Section 2.0 - Specification for Abatement and Selective Demolition Amendment

Amendment #1

RE: Notice of Starting Work - Premise Address: 130 Cedar Street – Manhattan
TRU# 1789MN06 VAR# 2692MN06

PROJECT:
130 CEDAR STREET HOTEL
BUILDING RENOVATION & ADDITION
130 CEDAR STREET, NEW YORK, NY
SKETCH DESCRIPTION:
FDNY LOGISTICS PLAN
GROUND FLOOR

CSK-Z001

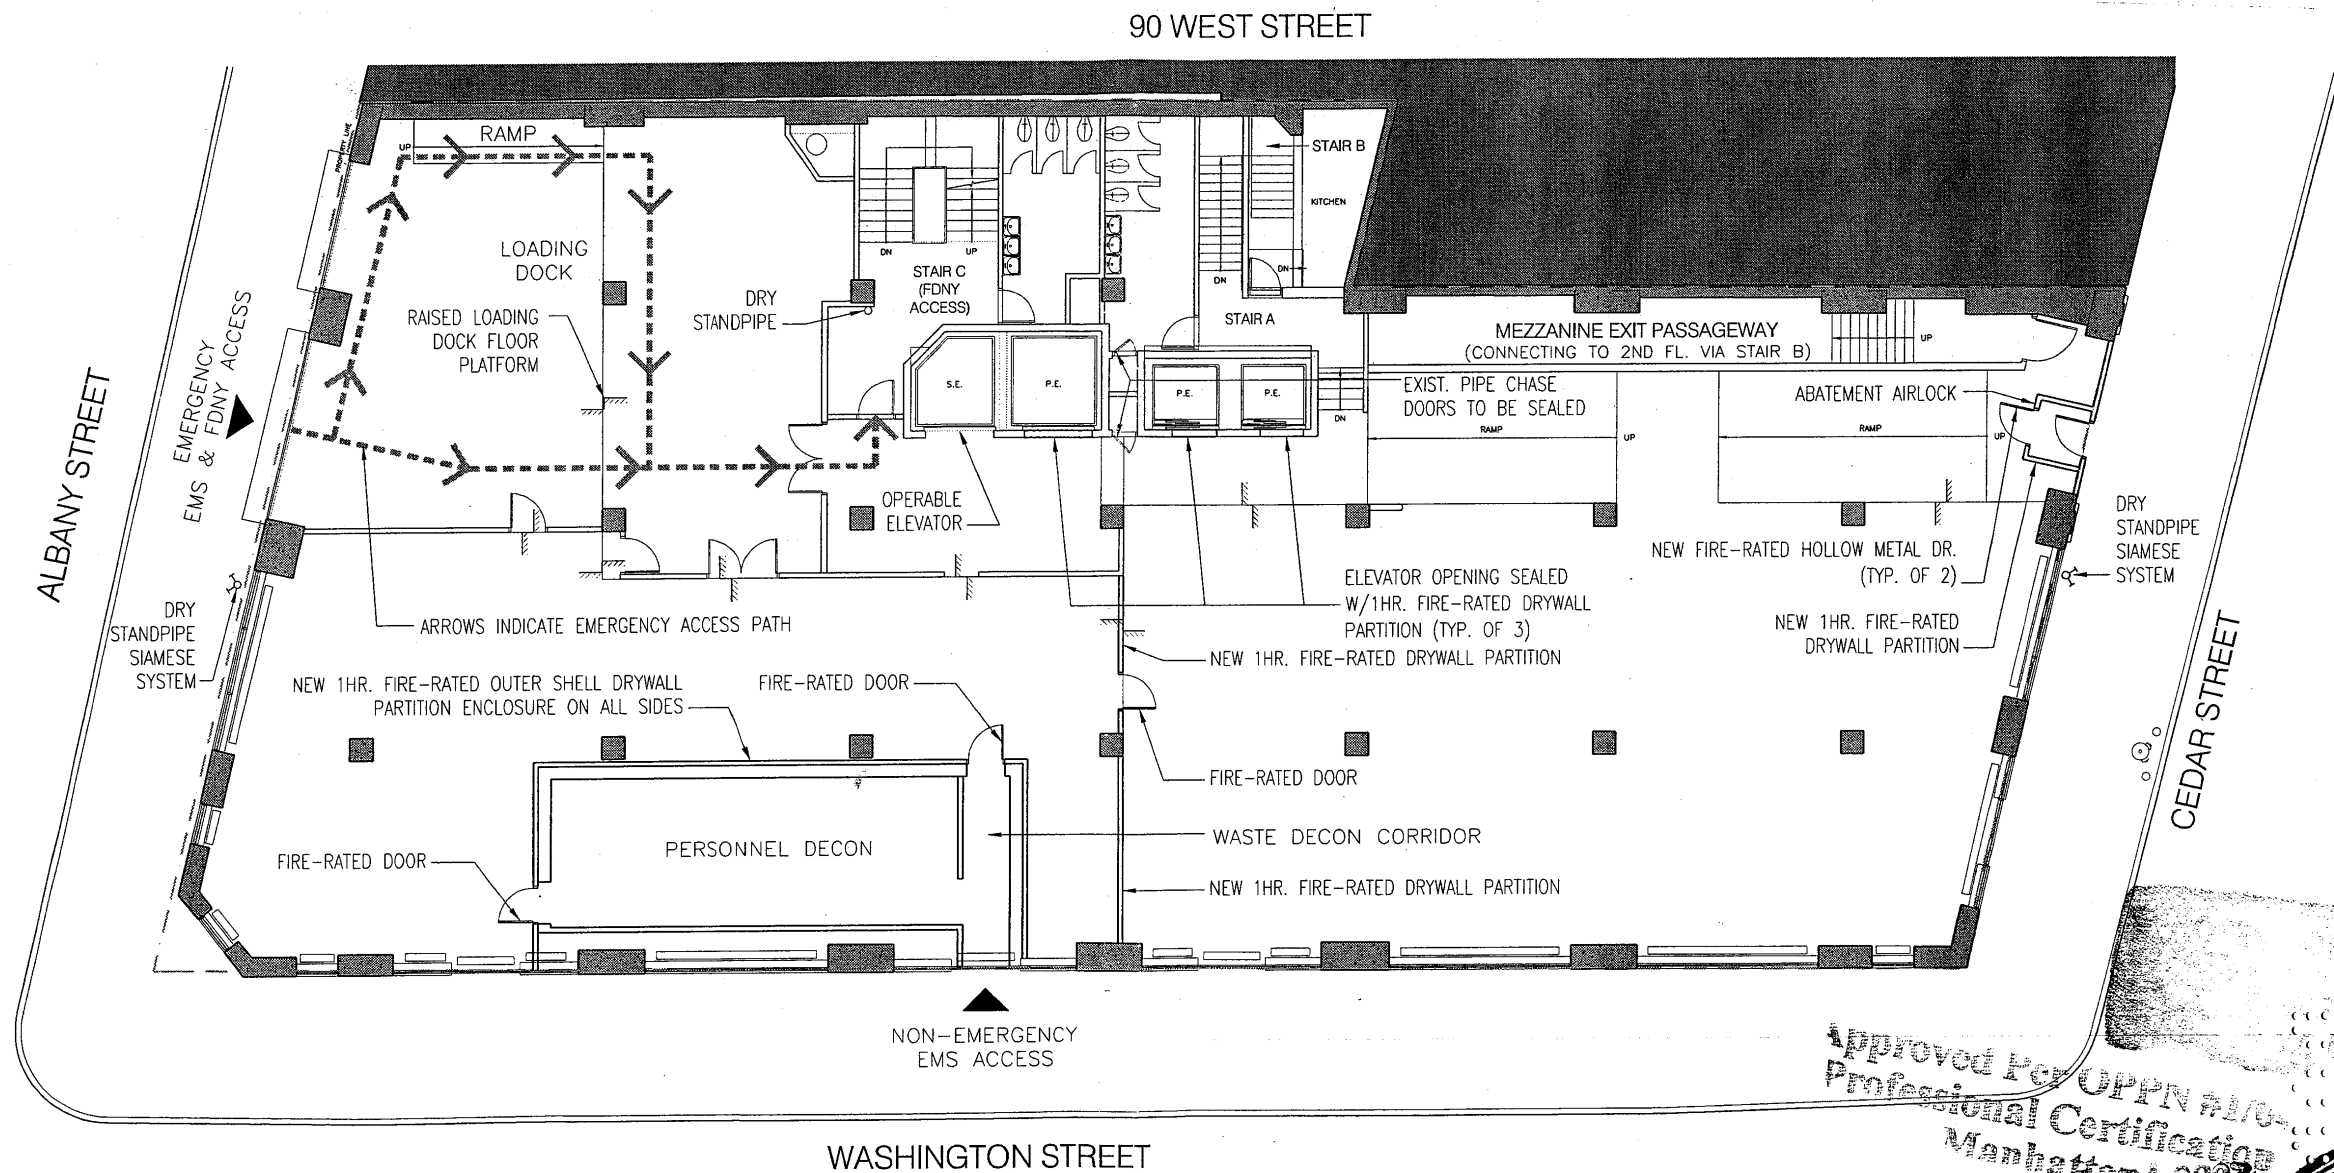
1. FIRE DEPARTMENT ACCESS THROUGH LOADING DOCK ON ALBANY STREET.
2. STANDPIPE LOCATED IN STAIR C
3. NON-EMERGENCY ACCESS THROUGH WASTE DECON FROM WASHINGTON STREET.

1. PHASE 1 ABATEMENT SHALL LAST APPROX. 6 WEEKS FROM START OF ABATEMENT.
2. DECON CHAMBERS & CLEAN AREAS TO BE RECONFIGURED IN PHASE 2. A SEPARATE SKETCH SHALL BE SUBMITTED FOR FDNY APPROVAL PRIOR TO COMMENCEMENT OF PHASE 2 ABATEMENT.

CSK-Z002

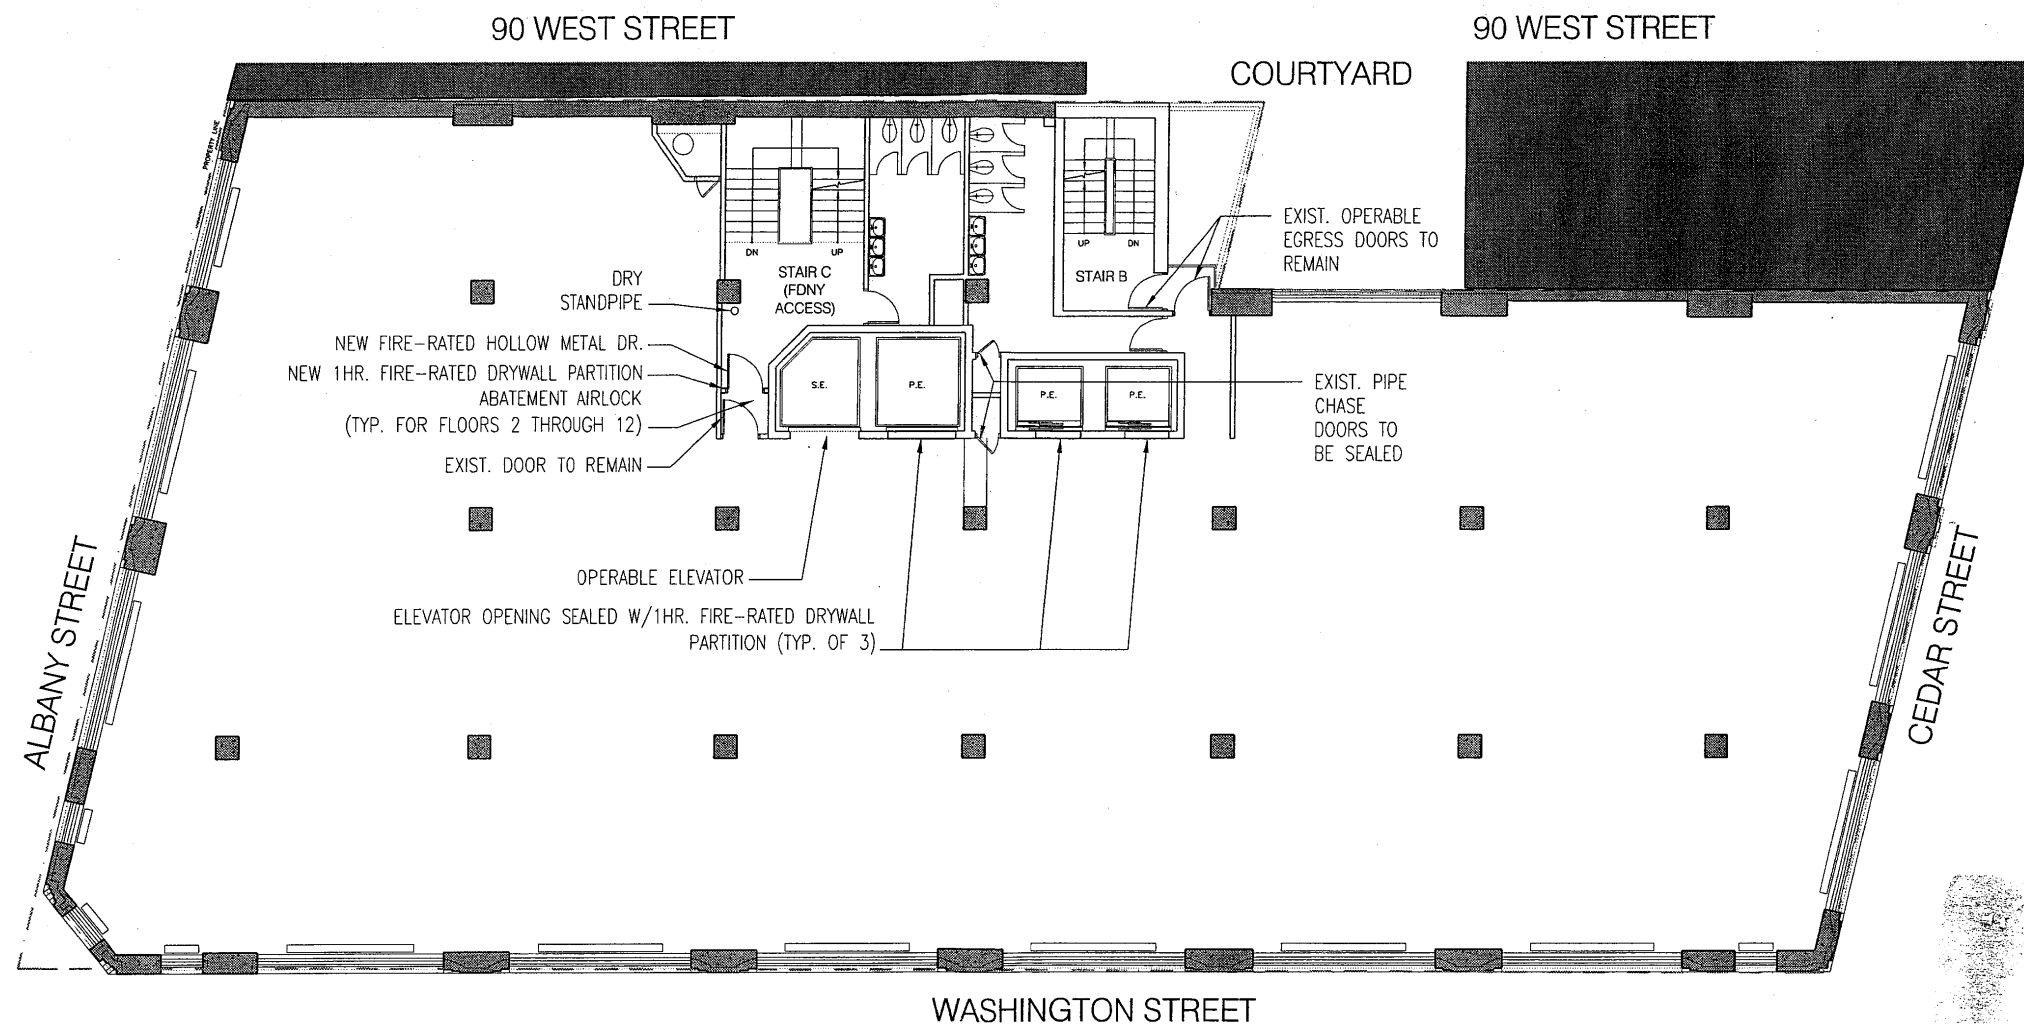
Nova has constructed fire resistant airlock walls in place of a kick out panel on floors 2 through 12 in the main stairwell to gain access to each floor in case of an emergency.

- The airlock wall is constructed of metal studs and 2 layers of sheetrock from floor to ceiling and attached to the existing walls on each side as shown on the attached diagram. All seams of each layer of sheetrock are staggered and sealed with fire rated caulk.
- Each wall has a fire-rated metal door installed to enter the airlock from the stairwell and will remain **closed** at all times during the cleaning process.
